# SERVICE No. 1035A BULLETIN

**Distribution of Textron Lycoming Service Bulletin 529B, "Reprint of Crane/Lear/Romec Service Bulletin No. 101SB020, Rev. 3"**

Service Bulletin No. 529B  
(Supersedes Service Bulletin No. 529A)  
Engineering Aspects are  
FAA Approved

## FUEL PUMP – Torquing of Relief Valve Cover Screws.

Torquing Sequence – RG17980 Series  
Figure 1

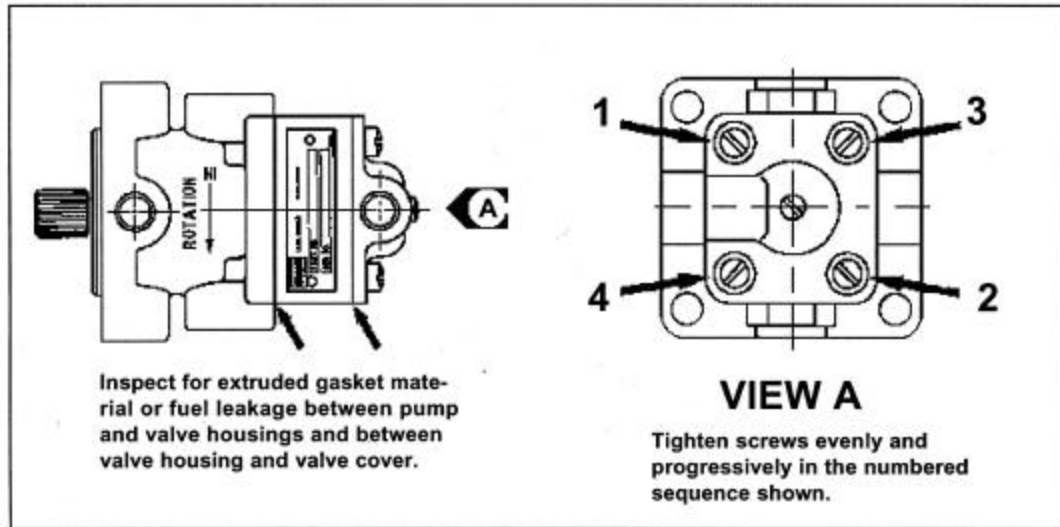
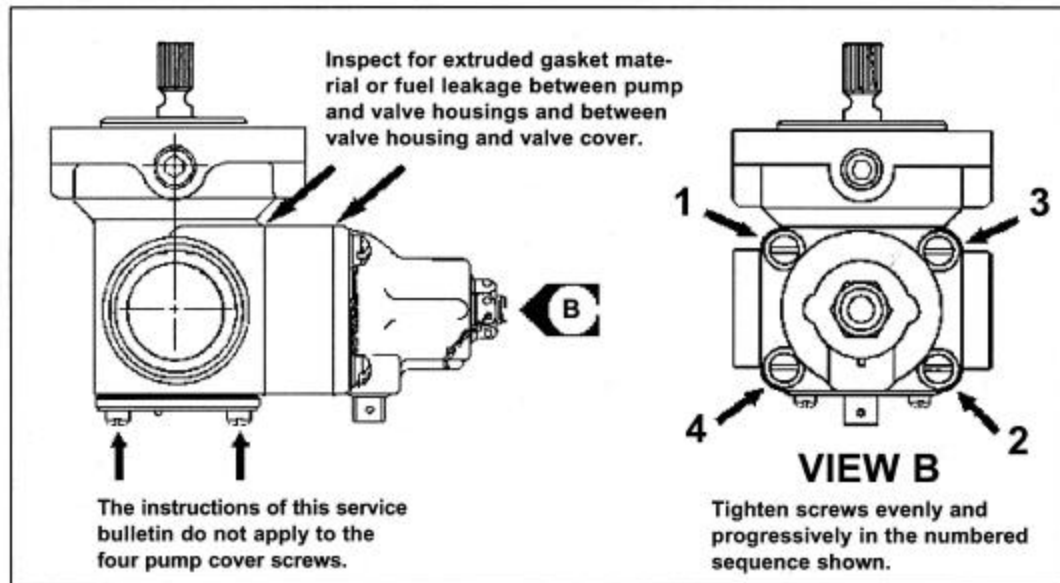
- (c) If screws are loose, tighten screws evenly and progressively in a criss-cross pattern to 23-25 inch-pounds torque in the sequence shown in figures 1 and 2.

**NOTE:** If screw torque registers greater than 23-25 inch-pounds when inspected per paragraph 2.A.(2)(b) above, the screws need not be backed off and retorqued. This bulletin applies only if screws exhibit preload torque of less than 23 inch-pounds.

Excessive Extrusion – All Series  
Figure 4

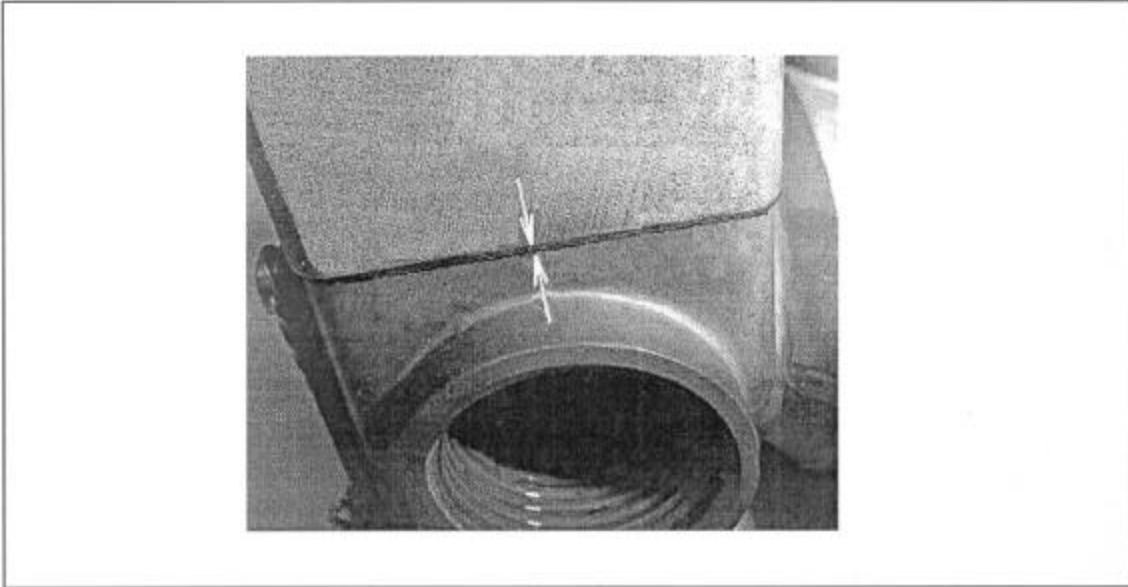
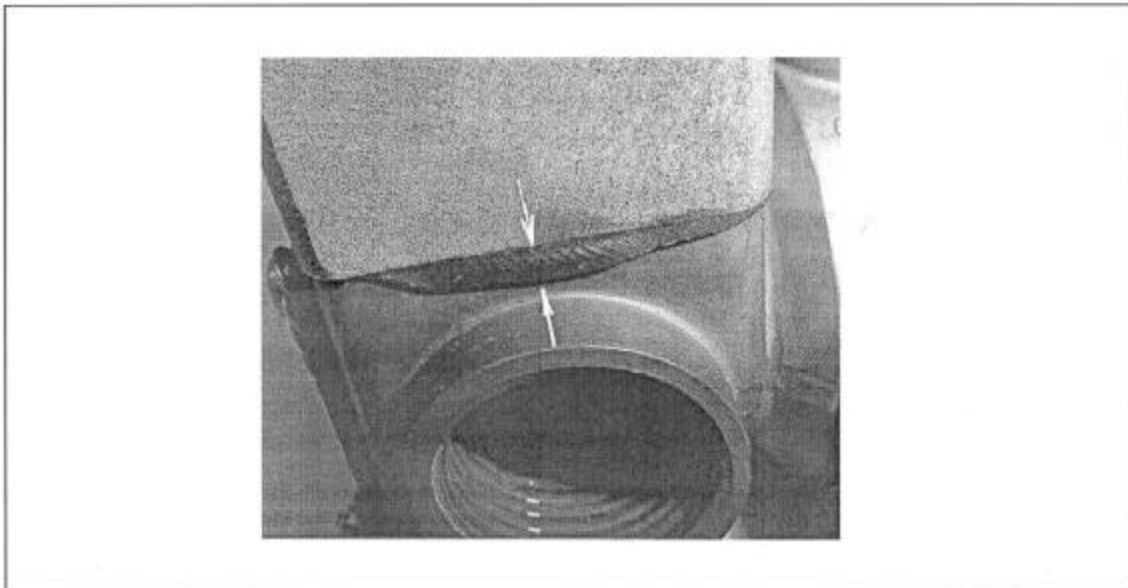
- (a) Visually inspect the split lines between the pump housing, relief valve housing and relief valve cover for evidence of fuel leakage or noticeable gasket extrusion adjacent to the pump inlet and outlet ports. If there is evidence of fuel leakage or noticeable extrusion, replace the pump per applicable engine maintenance instructions. (See figures 1,2,3 & 4.)
- (b) Check the tightness of relief valve cover attaching screws using a torque indicating screwdriver. Minimum torque shall be 23 inch-pounds. Torque shall be checked in the tightening direction.
